HISTORIC DISTRICT COMMISSION ADDITIONAL INFORMATION REQUEST

Application Number: HDC2025-00662

PROJECT ADDRESS: 15042 Stahelin Ave

HISTORIC DISTRICT: Rosedale Park

STREET VIEW 1/4" = 1'-0"

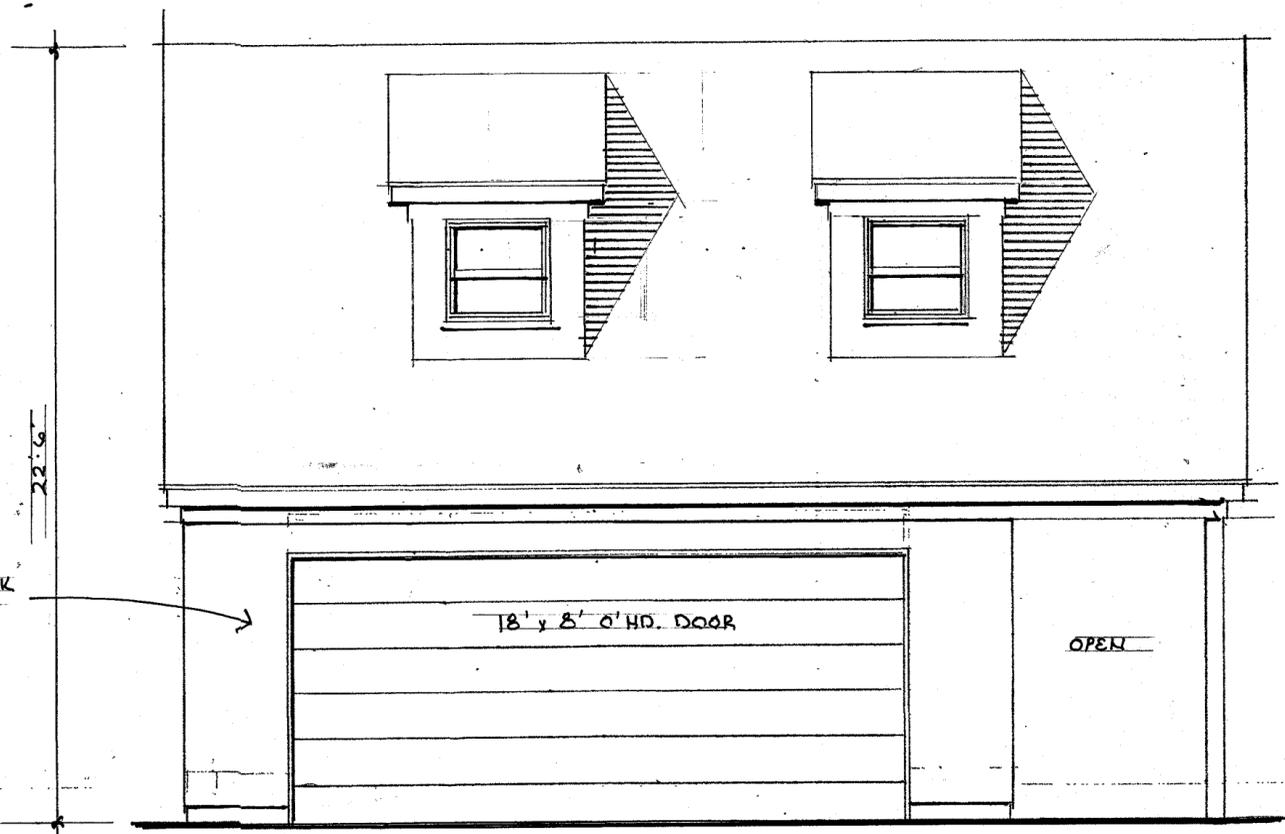
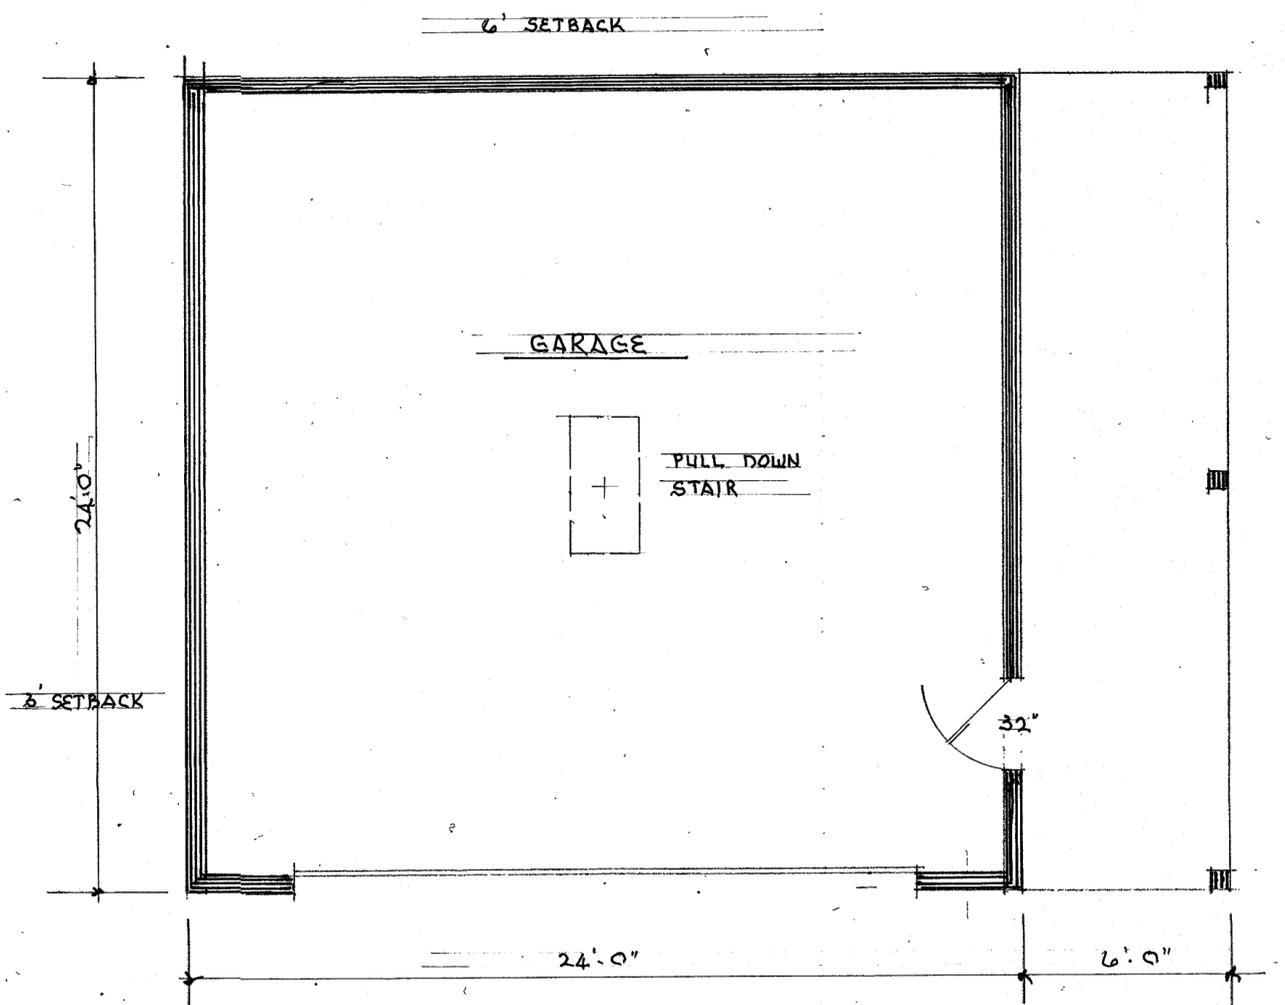
- o Floor Plan (submitted)
- o Elevation Drawings – a drawing of each elevation of the garage is necessary to confirm/show the complete proposed design. A revised front elevation is necessary to reflect the design change of two dormers to one three-window dormer.

-Please see the additional 3D renderings of the garage plans that show the revised front dormer as well as the placement of materials.

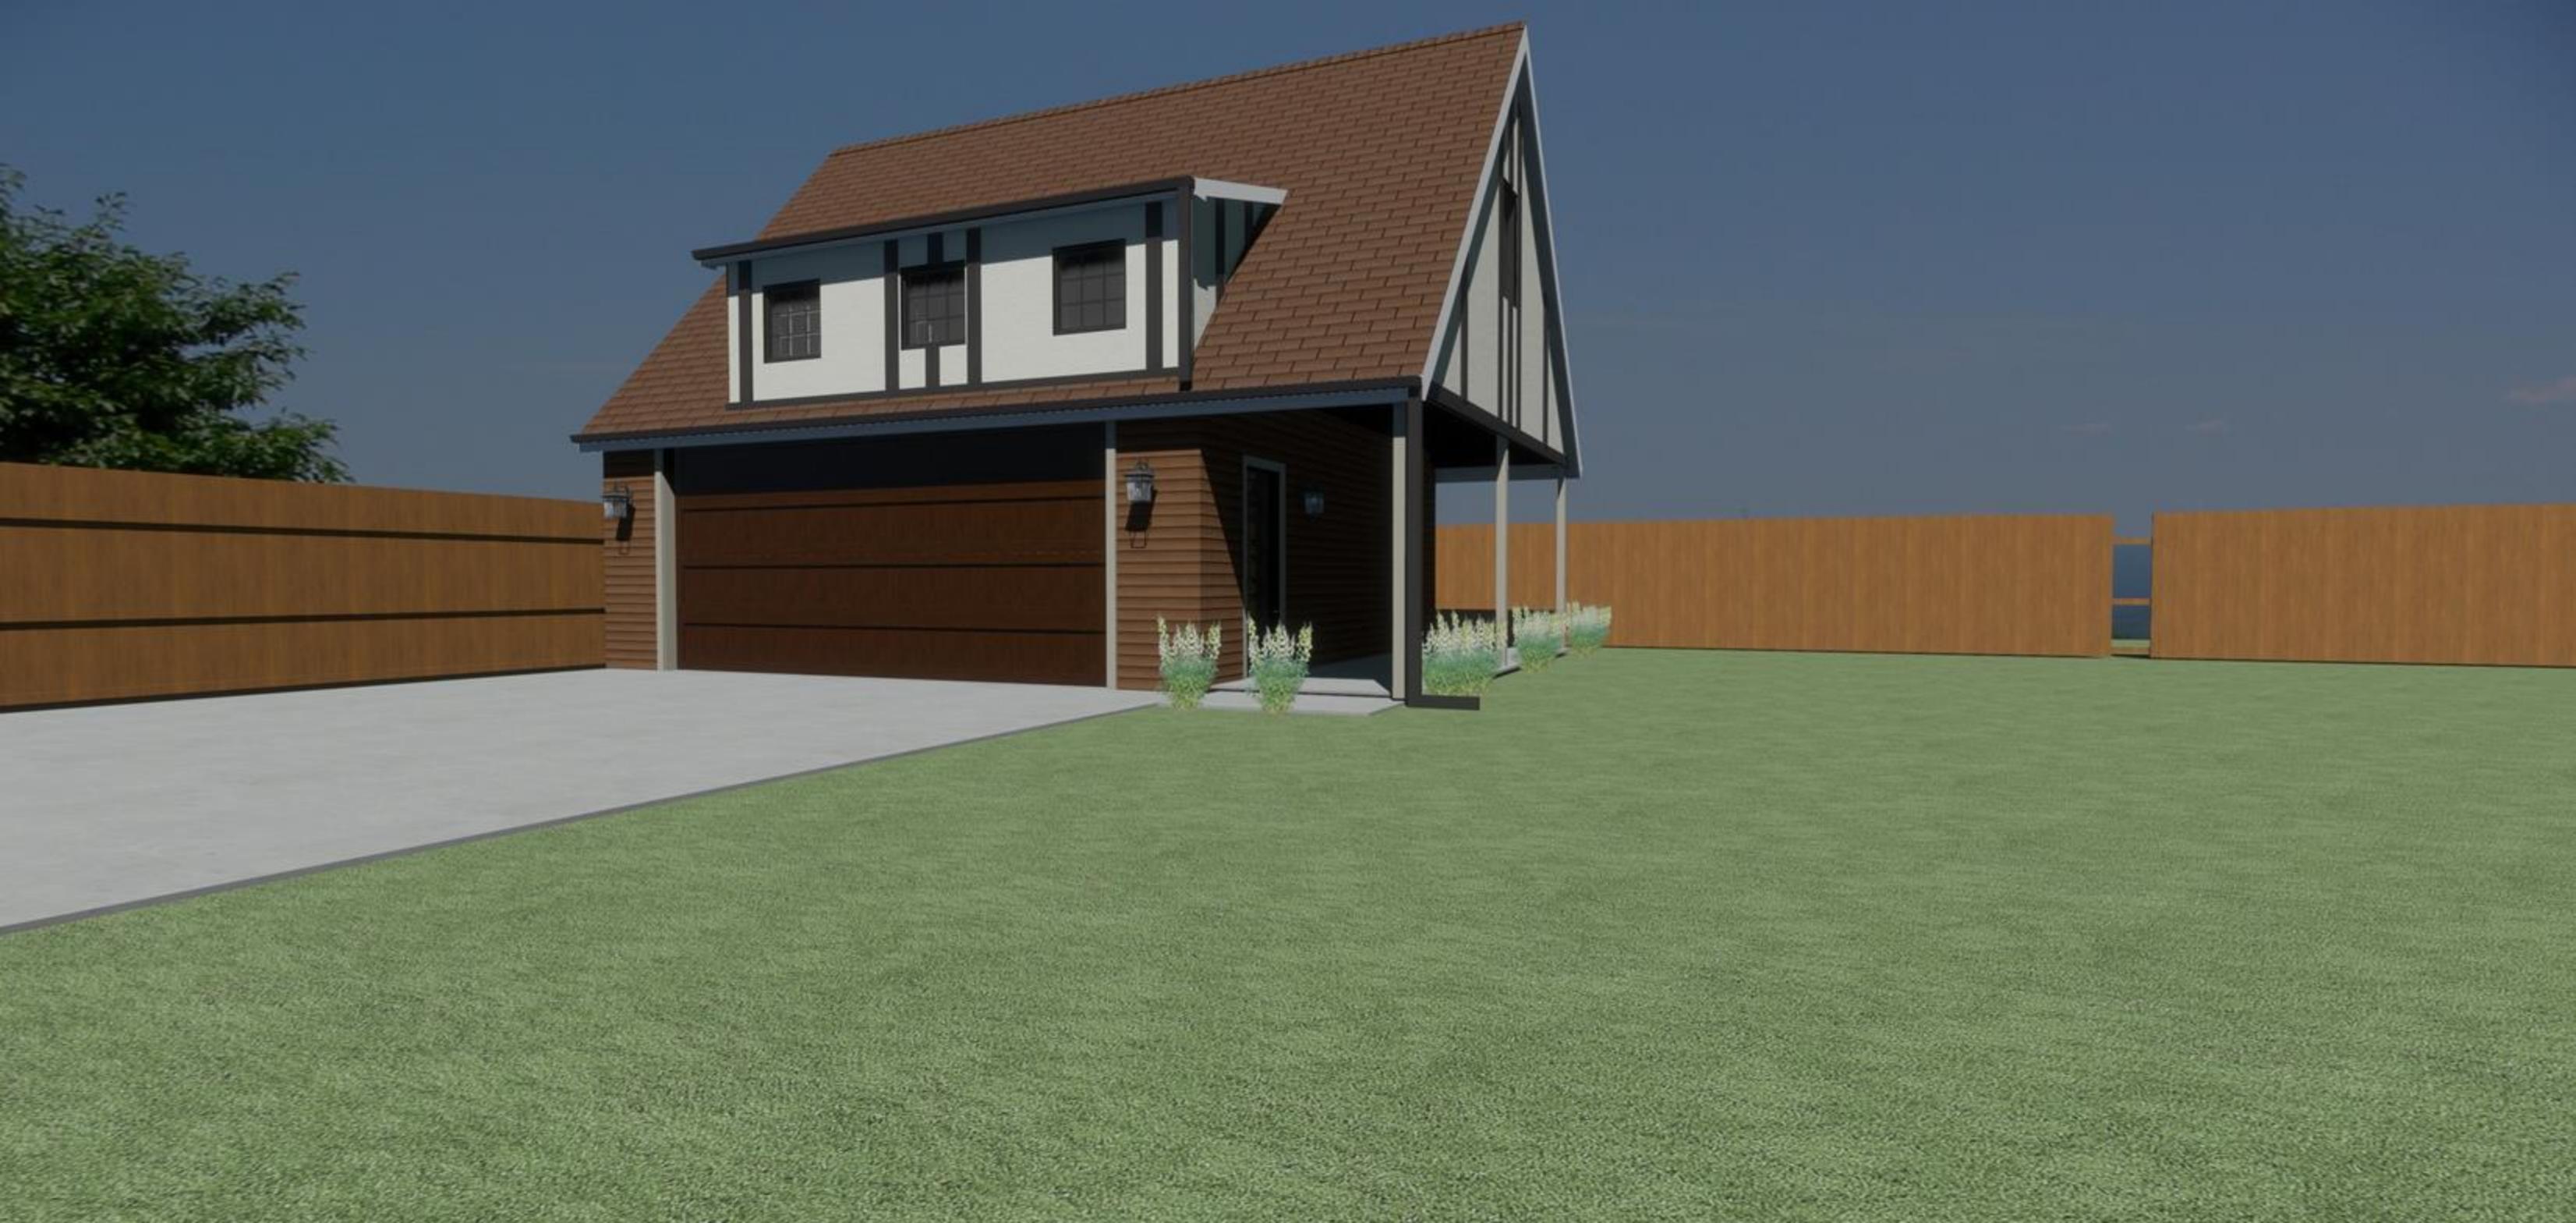
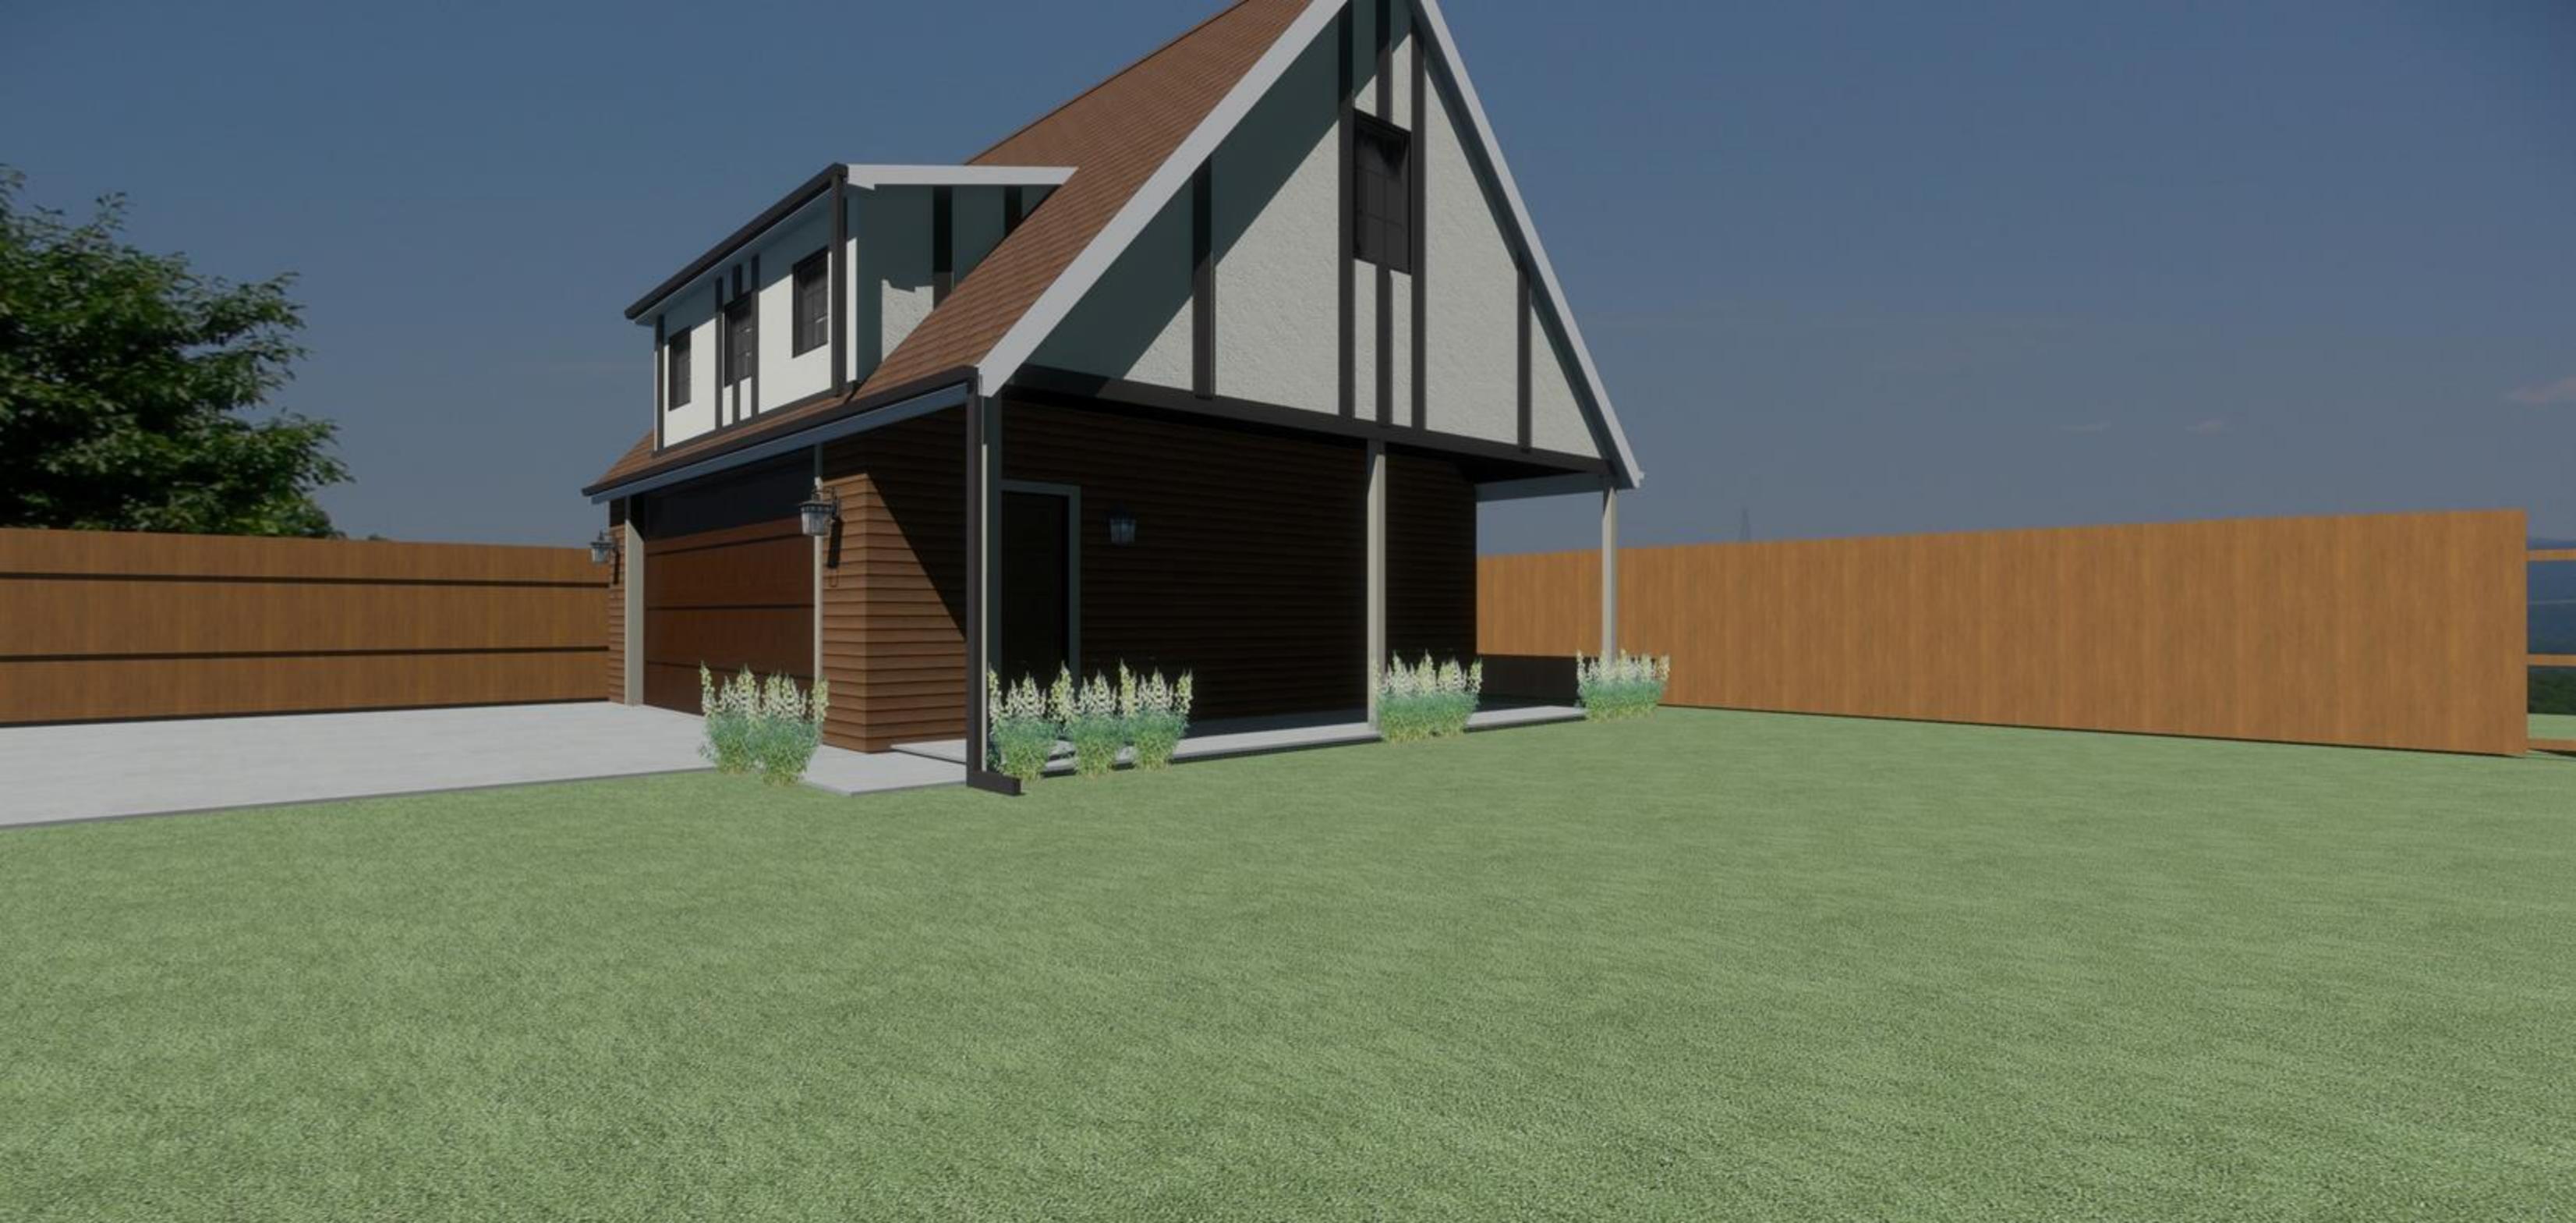
- o Site plan must be accurately drawn and dimensioned. The site plan on the contract isn't accurate and depicts a rectangular garage shape that is much narrower than the proposed square, 24' x 24' garage with 6' patio. Include the open distance between the front/west wall of the garage and rear/east wall of the existing house, as well as any additional changes to hardscape and landscape features, including location of construction fencing if applicable.

-I am resubmitting the site plan sketch with written dimensions as well as the original architect drawing for ease of reviewing. Please note that the written dimensions are accurate to the space and plan for this project. The contractor's thumbnail sketch of the property and new construction within was drawn to fit a space on the formal contract, but not to scale. Again, the written dimensions here are accurate.

-The new garage will be 24x24' with an attached patio of 6x24'. Total dimensions of this space are 24x30'. The new distance between the garage and the house will be 24' (the existing distance is 30' between the garage and the house. The driveway will be 30' wide, narrow down to 8'6" by the house and continue for 66', following the same path as the existing driveway.
